Product Change Notice (PCN)

Subject: Change in Marking Format on Select Device

Publication Date: 3/6/2023

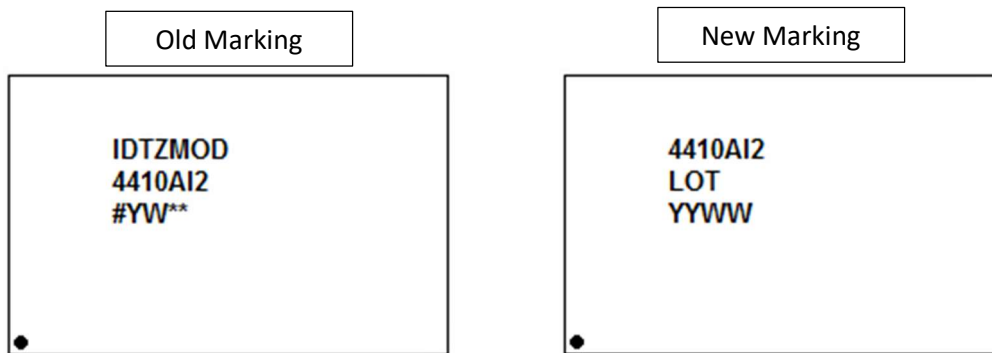
Renesas is changing the marking format on ZMOD4410AI2R and ZMOD4410AI2V to align with the AI1 version of the device as shown in the below diagram.

where Line 1: IDT + Device part number
 Line 2: Device part number
 Line 3: # Stepping
 YW Datecode
 ** Lot sequence

Line 1: Device part number
 Line 2: Lot number
 Line 3: YYWW Datecode
